# Author response to Review comment by Martin Mergili for “Formation, breaching and flood consequences of a landslide dam near Bujumbura, Burundi”

10 In this document, the Reviewer comments are shown in the boxes and are directly followed by the authors' response.

**Figure R1.** Longitudinal profile (in the dam area) of the bed and water levels for a steady discharge of  $120 \text{ m}^3/\text{s}$ , as computed in Step 1 of the hydraulic modelling procedure ( $k_s = 0.3 \text{ m}$ ).

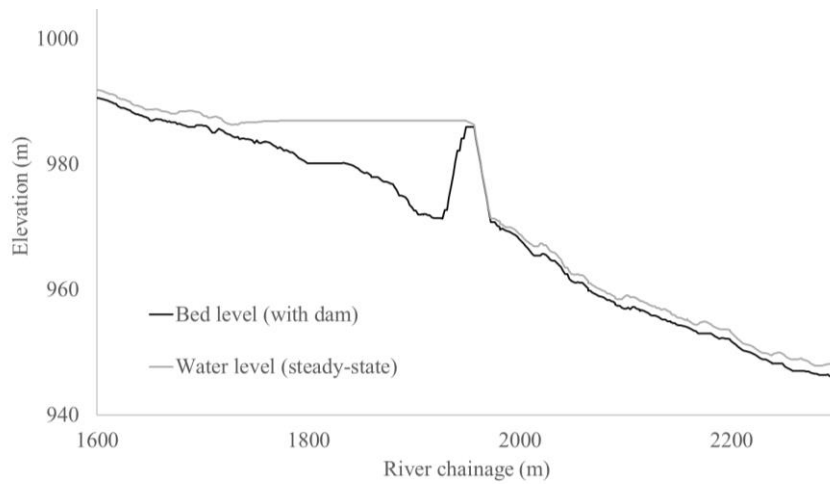
2.2. I do not fully understand the work flow of the flood modelling: in the first step, do you (i) simulate the base flow without the dam incorporated, or do you (ii) fill the lake behind the dam to let it flow out in the second step? The description in Sect. 2.4.3 is confusing and has to be improved.

85 In the first step, we fill the lake behind the dam to let it flow in the second step. This will be clarified in the revised manuscript, by introducing a new table (Table R3) and by rewording section 2.4.3 as detailed hereafter:

Examples of results of Step 1 and Step 2 are displayed in Fig. R1 and Figs R2 to R5, respectively.

**Figure R6.** Plane view of the topography evolution in the near-field of the landslide dam as a function of time ( $T_f$  stands for the breach formation time).

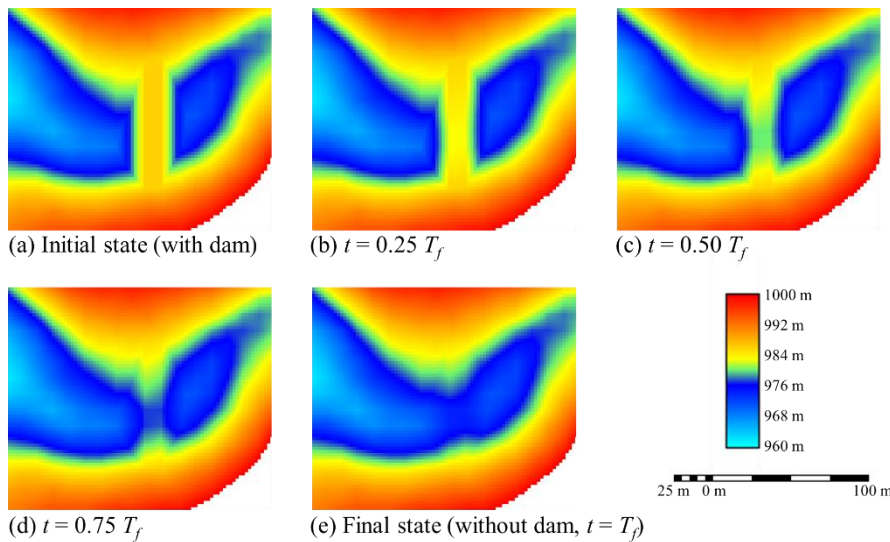
2.3. A highly critical issue is also the consideration of dam breach (lowering of the dam crest and release of the impounded water) – how does this work? Please explain! I have the feeling that you spend a lot of effort in describing base flow and lower boundary conditions at a high level of detail, but do not explain some of the really important aspects at all.

150 As sketched in Fig. R6, the parametric breach model was implemented in the 2D flow model by means of a time varying topography. The breach outflow is thus explicitly computed by the flow model, enabling the representation of the hydraulic coupling between reservoir depletion, flow through the breach and possible backwater effects. This procedure requires a user-defined initial dam geometry (Fig. R6a) and a user-defined final geometry corresponding to the breached dam (Fig. R6e). In-between these two geometries, the algorithm performs a linear interpolation in time (Dewals et al. 2011). The breaching duration also needs to be prescribed by the user.”

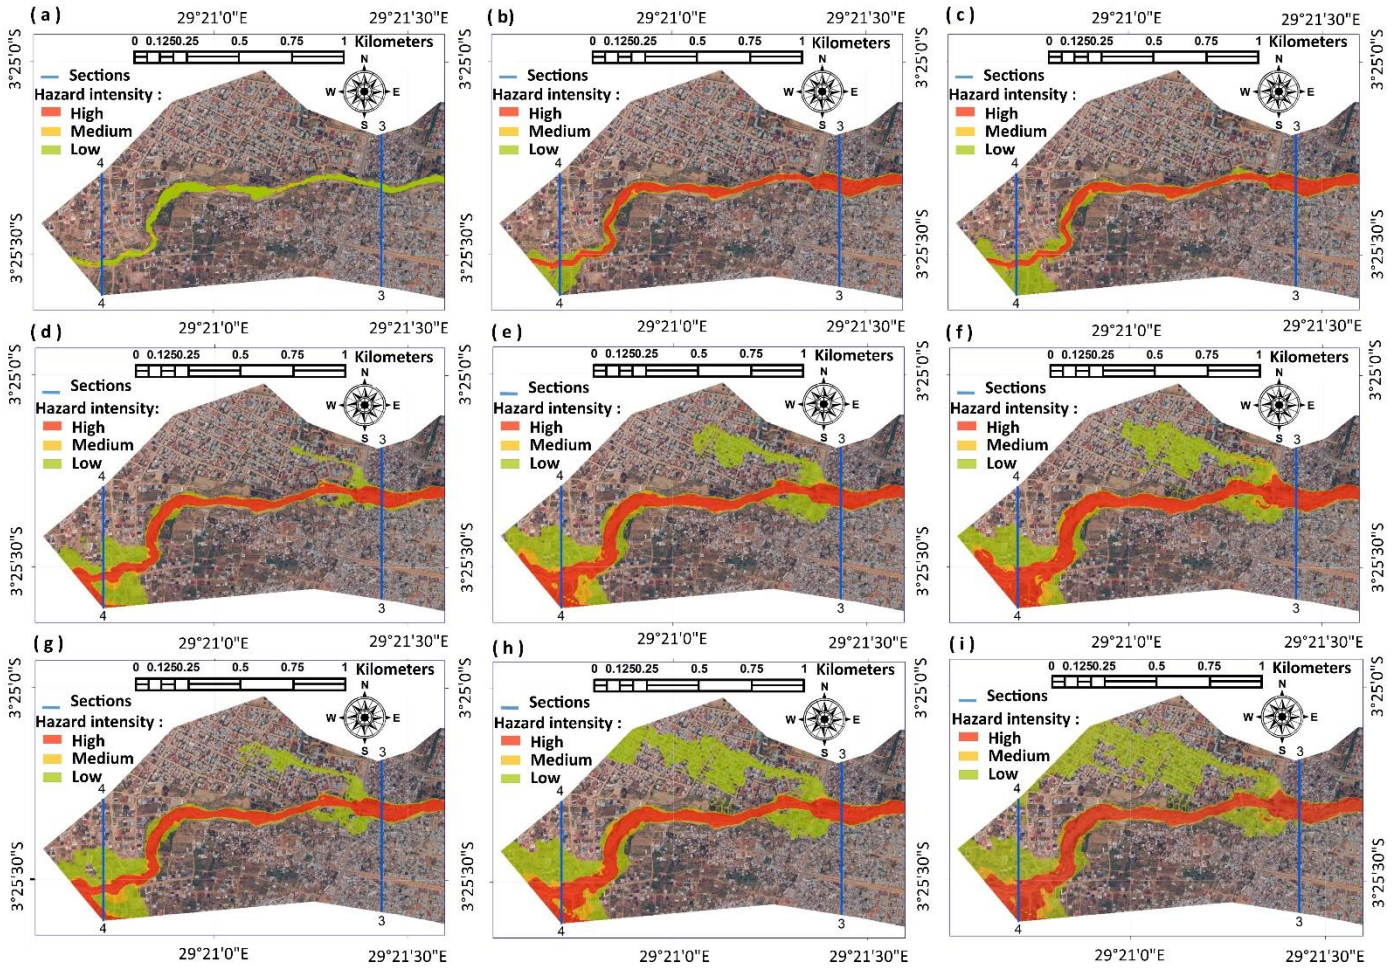
280 2.4. You claim to consider flood hazard – however, it is only the possible intensity which is used for the preparation of the maps – hazard would also have to include a measure for frequency. Some rewording (e.g. flood intensity indication map?) will be necessary.

Figure 13 will be improved, including results of the gradual failure. The modified figure 13 in the revised manuscript will include results of a gradual failure corresponding to 10 minutes and 60 minutes as breaching time. That means that 2 more columns (6 maps) are to be added. However, adding new elements (12 maps instead of 6) in the same figure significantly reduces the visibility of the legend and the other texts that are incorporated into it. That is why Fig. 13 will consist of 2 figures: Fig. 13a (including only one more column for failure scenarios with 10 minutes as breaching time) and Fig. 13b (including failure scenarios with 60 minutes as breaching time).

We agree and we will revise the terminology throughout the manuscript, as it is already done in the legend of the maps within Fig. 13a and Fig. 13b proposed above.

320 **Figure R7.** Extent of the field measurements (●), of the river banks (—) and of the computational domain: (a) lower part of the valley, (b) middle part and (c) upper part.

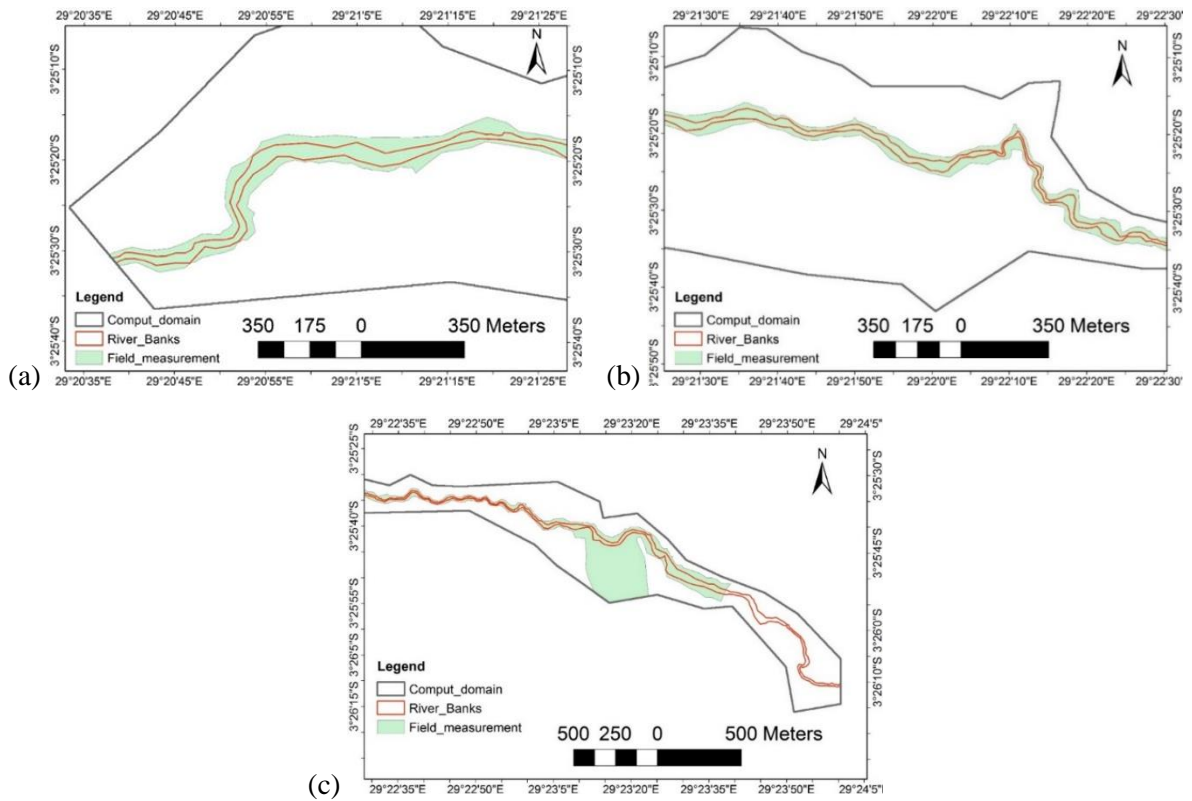
285 2.5. You resample the 10x10 m DEM to 2x2 m. it is absolutely clear to me that this is necessary for numerical reasons – still, it does not increase the level of topographic detail. How wide is the river, i.e. is an effective 10x10 m cell size sufficient to capture the topographic patterns governing the flow? Please discuss.

Besides, we conducted field surveys during the dry season (June-September) in 2014 and in 2015. The surveys covered the main riverbed and part of the floodplains (band of 10-20 m) of Kanyosha River, from 500 m upstream of the dam down to Lake Tanganyika. Fig. R7 shows the extent of the field survey, compared to the position of the banks of the river and to the limits of the 10 m × 10 m DEM used for hydraulic modelling. The available equipment  
310 did not allow measurements in the lake (this is the reason why we present in the manuscript a sensitivity analysis with respect to the downstream boundary condition).
